UNITED STATES PATENT AND TRADEMARK OFFICE

APPLICATION NO.	FILING DATE	FIRST NAMED INVENTOR	ATTORNEY DOCKET NO.	CONFIRMATION NO.
10/816,245	04/01/2004	Larry A. Strobel	870199.401	9227

Office Action Summary

DETAILED ACTION

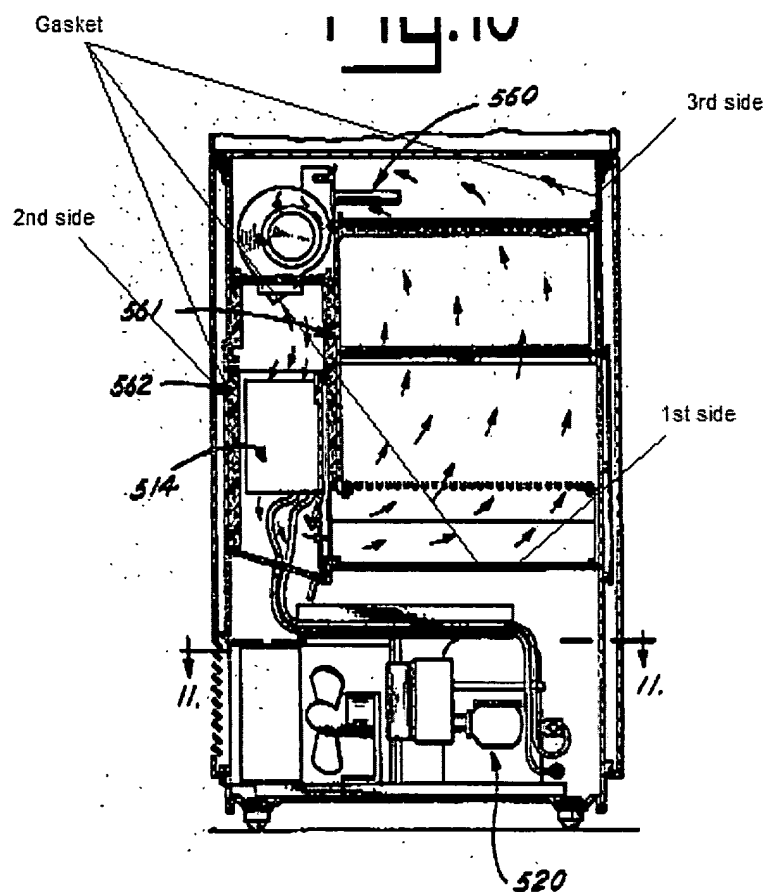
first region and a second region (The gasket (561) prevent the warm hot air of the first region from entering the second region (Where the PC is located)); and a cooling unit (514) positioned within the cabinet, the cooling unit configured to draw air from the first region of the cabinet (Between the fan and the evaporator), cool the air and output the air into the second region of the cabinet (Where the PC is located).

With respect to claim 9, Anderson et al. further teaches a gasket (See present office action Fig 1 below) configured to substantially seal a space between an interior of surface of the enclosure and the exterior of the personal computer case, on three sides of the case.
